Proposal for updating the test mass realtime control library

K. Izumi for VIS and commissioning teams
2018 Jan. 24th

Proposal (a)

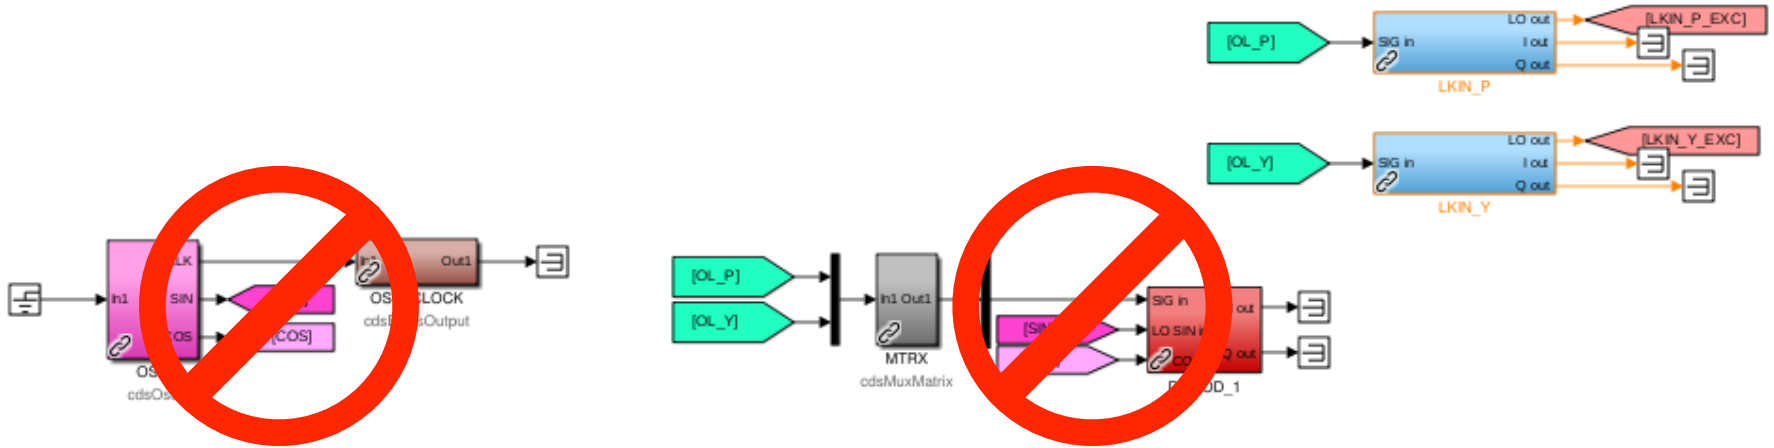
OPTICALIGN doesn't have to be at the bottom stage. Remove it.

Proposal (b)

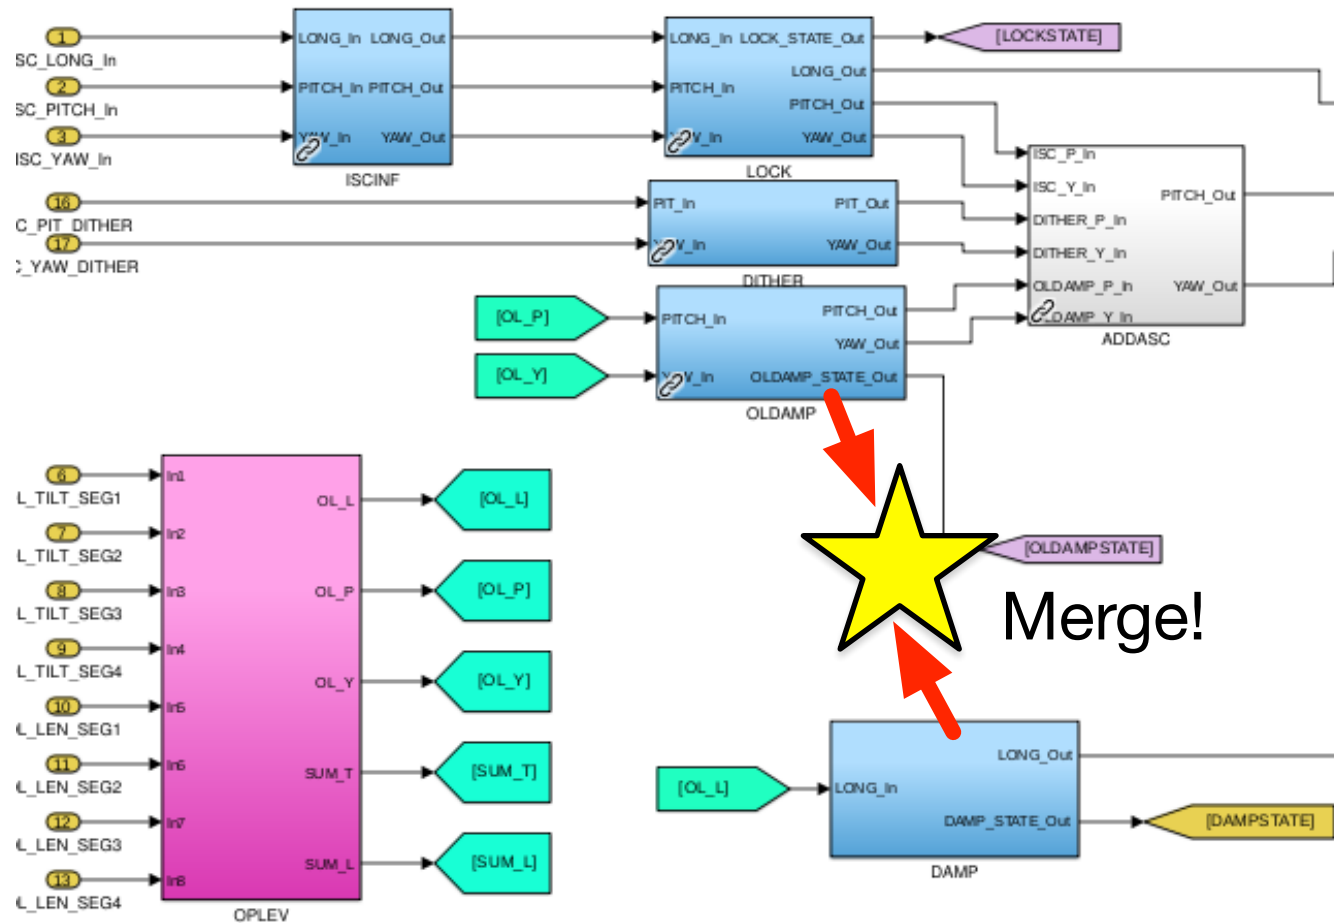
They don't seem to be useful. The clock output is not even going anywhere. Also, the LKIN blocks (shown upper right) can do the same job.

Proposal (c)

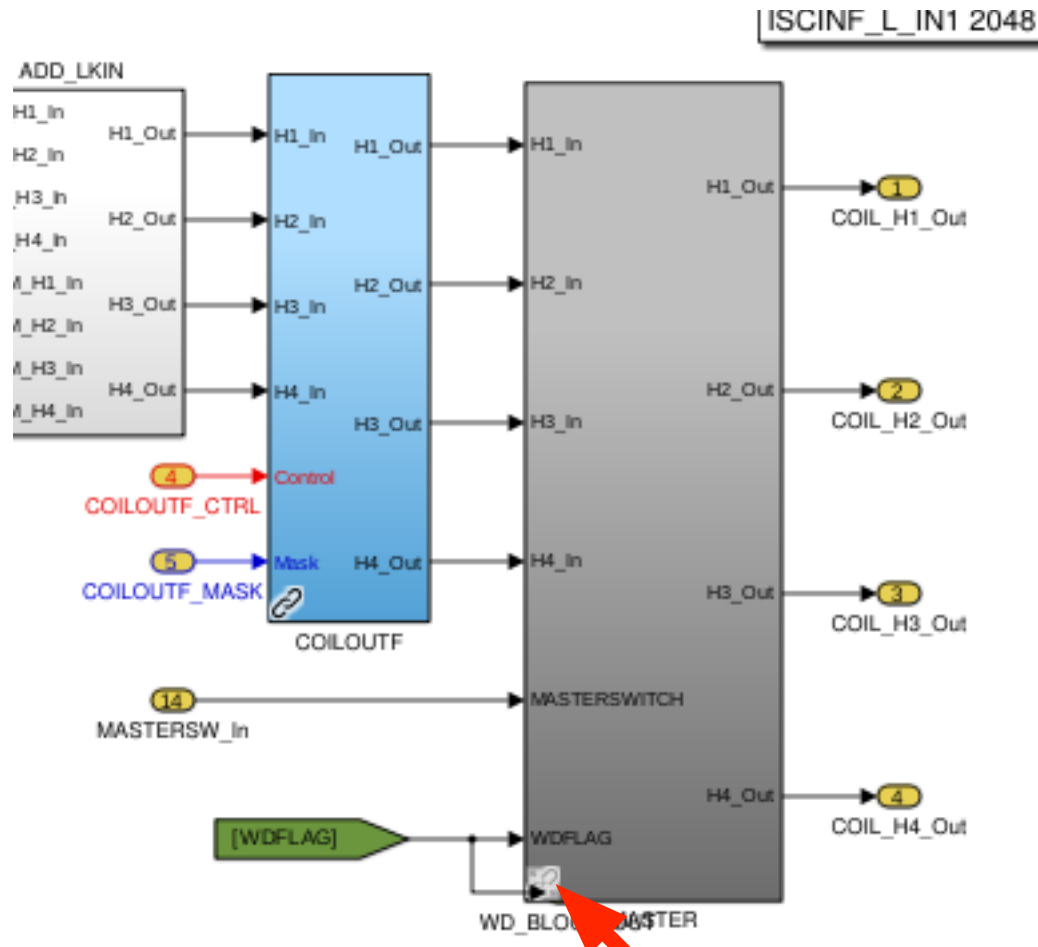
Also, make a new library block in VIS_LIB.mdl that contains the functionalities of both OLDAMP and DAMP.

Proposal (d)

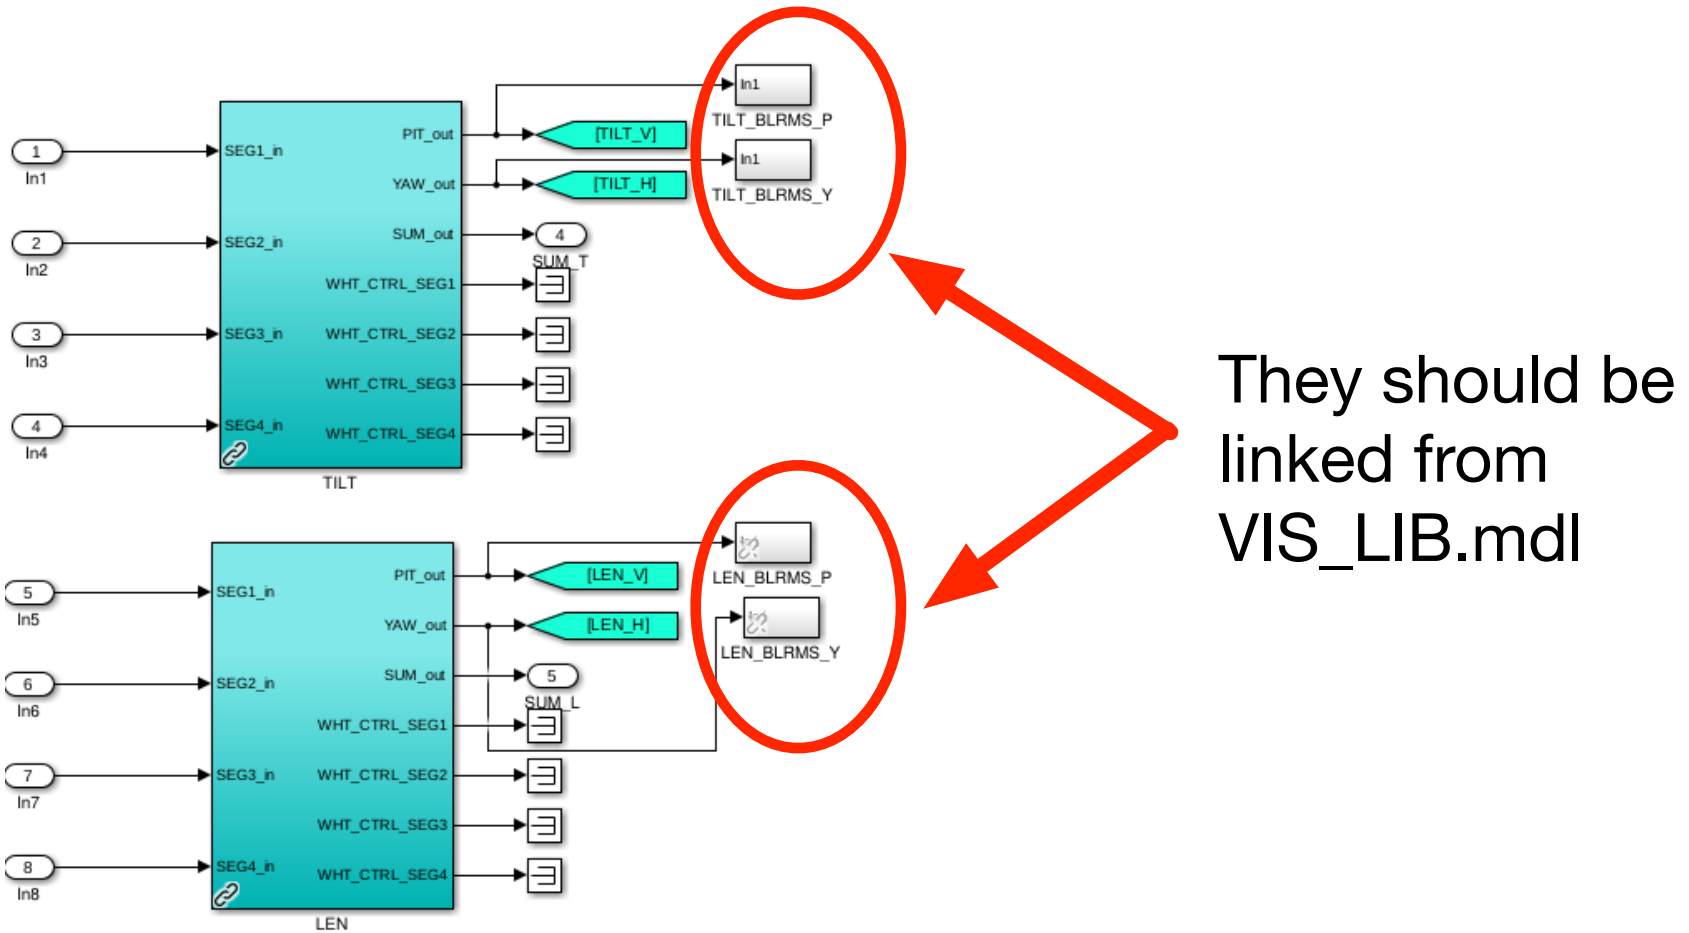
Recover the link.

Proposal (f)

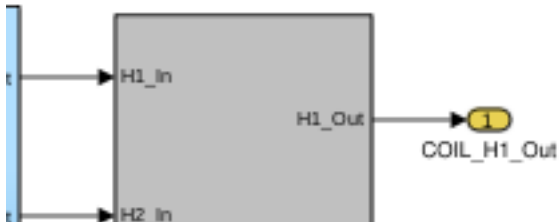
```
#DAQ Channels  
OPELV_TILT_SEG1_IN1 2048  
OPELV_TILT_SEG2_IN1 2048  
OPELV_TILT_SEG3_IN1 2048  
OPELV_TILT_SEG4_IN1 2048  
OPELV_LEN_SEG1_IN1 2048  
OPELV_LEN_SEG2_IN1 2048  
OPELV_LEN_SEG3_IN1 2048  
OPELV_LEN_SEG4_IN1 2048  
OLDAMP_P_IN1* 2048  
OLDAMP_Y_IN1* 2048  
DAMP_L_IN1* 2048  
OPELV_TILT_SUM_OUT 2048  
OPELV_LEN_SUM_OUT 2048  
ISCINF_L_IN1 2048
```

← Get rid of them.

Then, add the new test points for the diagonalized optical lever signals.
